CURRENT CONDITIONS /RELEASE ASSESSMENT
EAST HELENA FACILITY

September 1998

Revised January 1999

**RESPONSE TO EPA COMMENTS DATED NOVEMBER 30, 1998 ON THE CC/RA
REPORT DATED SEPTEMBER 1998.**

FIGURE 1-1-2 CC/RA REPORT ORGANIZATION

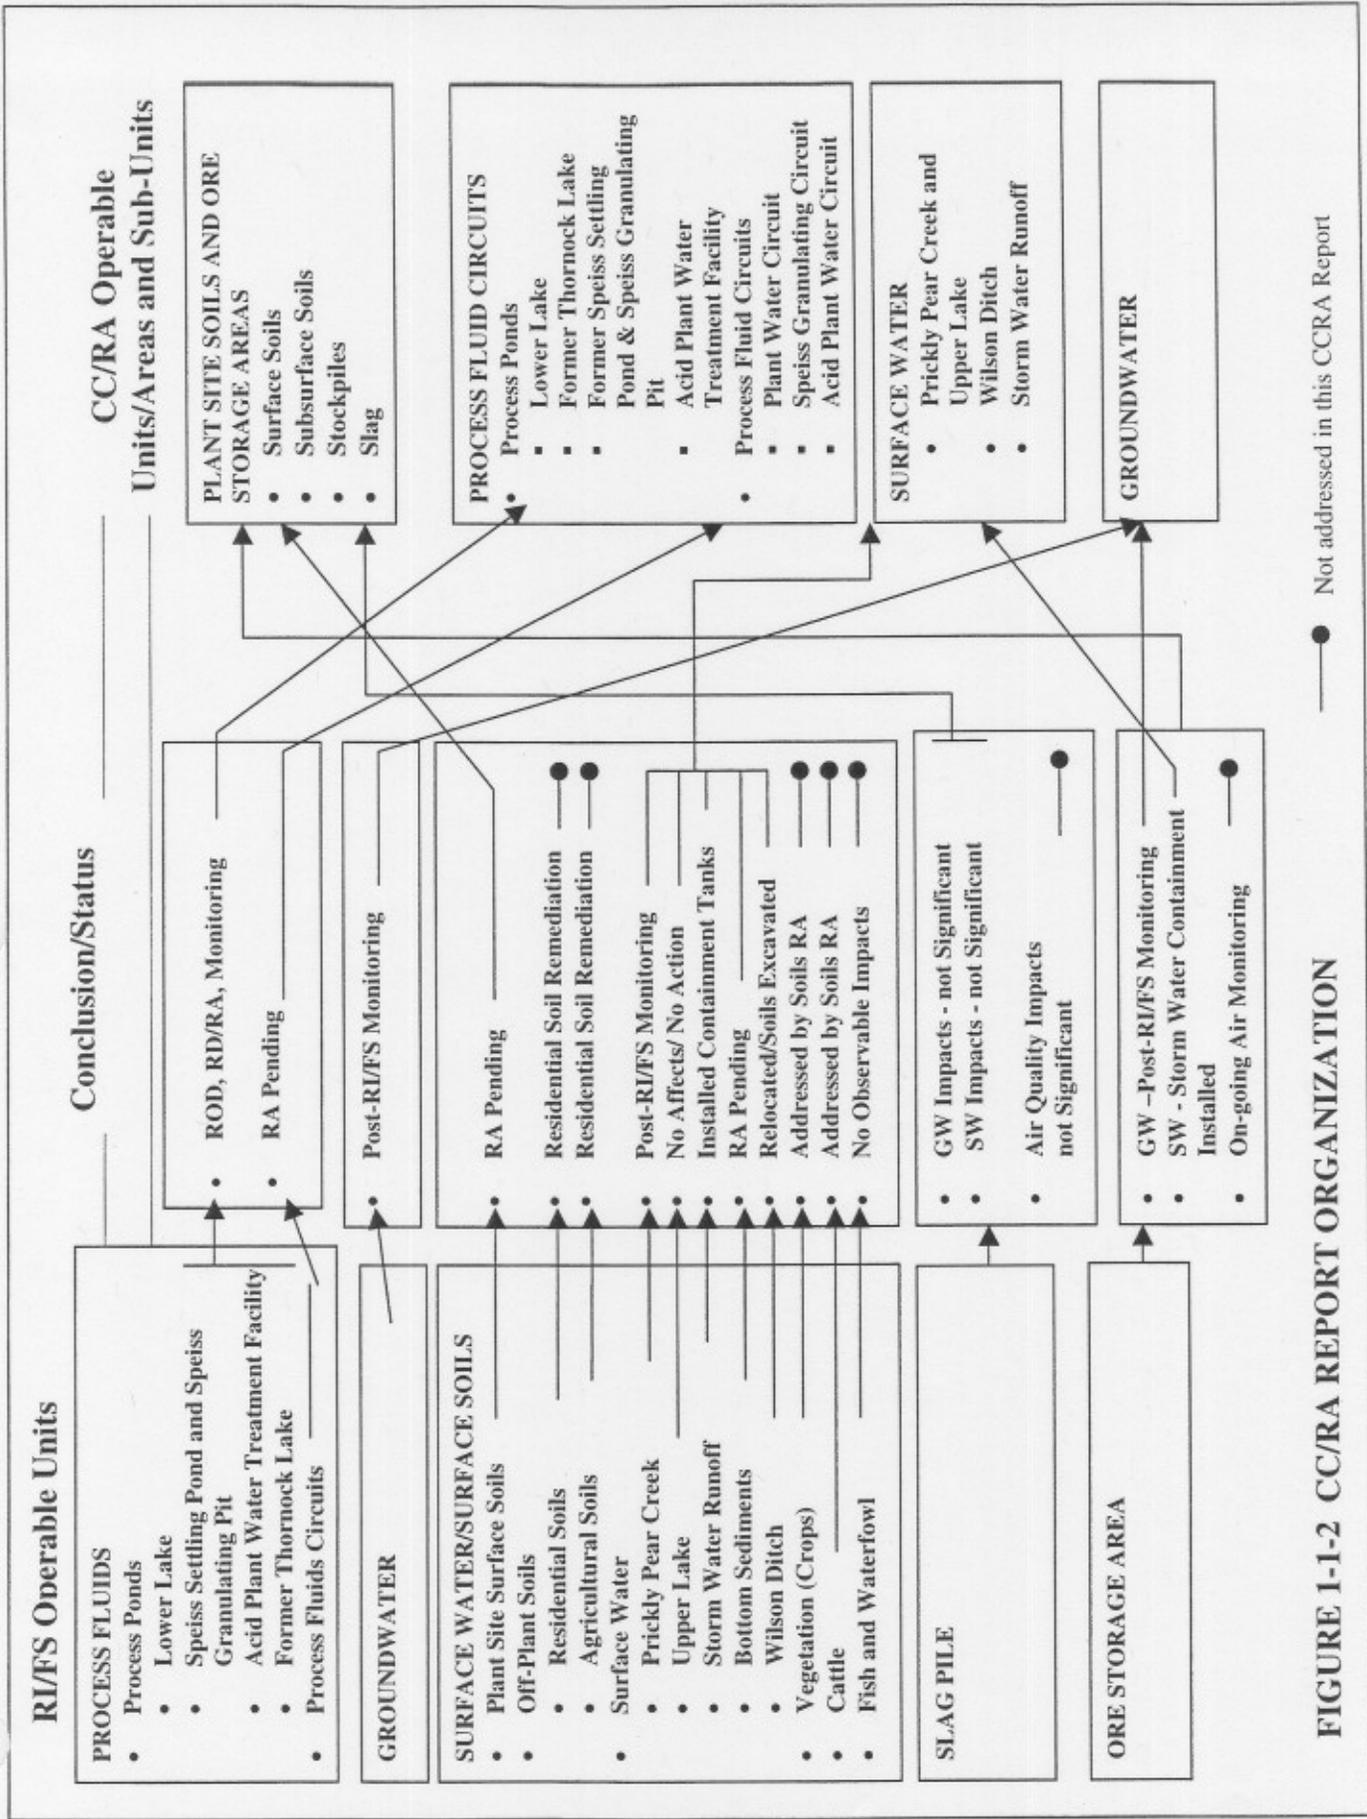
General Comment 2. As presently structured, the report is limited in scope to areas of concern or operable units developed under the Superfund remedial investigation and feasibility study (RI/FS). Since the RFI will fill in the gaps in existing information for all contaminated areas at the facility (not just the RI/FS operable units), the CC/RA should include one or more sections to the parts of the facility that are not RI/FS operable units.

One general medium type not included in the identified areas of concern is subsurface soil. Although subsurface soil was a component of some of the RI/FS operable units, it has not been adequately addressed in the report for most of the site. Subsurface soils are likely a primary source of contamination to groundwater at the facility. The report should provide a thorough discussion of existing subsurface soil sampling results, an analysis of the adequacy of this subsurface data for meeting the goals of the RCRA corrective action program, and Asarco's understanding of the nature and extent of subsurface soil contamination on the basis of the existing information. Specific discussion of subsurface soils in each chapter of the report would provide a much clearer description of potential vadose and saturated zone source areas or data gaps.

Response: All available data are presented for the site in the CC/RA. The CC/RA units do not directly correspond to the RI/FS Operable Units and this is shown in the CC/RA report on Figure 1-1-2.
